Access Compliance Report Public Rights-of-Way (Curb Ramps)

Main Street: ANTONIO_PKWY		Cross Street: N/A		Location:	E
ADA ID: RPRK211122113218	Ramp Type: Type 1 - Perpendicular Diagonal Initial Pass/Fail: Pass		Overall Compliance: No	Severity Score:	10

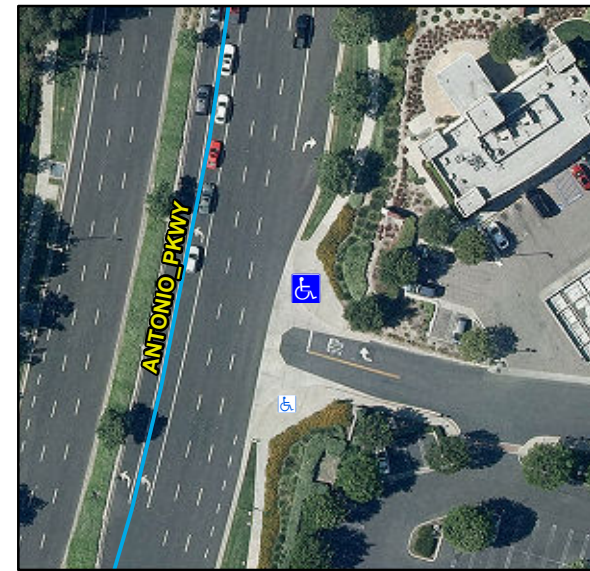
R304.2.2, R304.2.1, R304.2.2-Perp, R304.3.2-Para, R305, STD 1115

Remove & Replace Curb Ramp With Two New Directional Ramps or Equivalent.
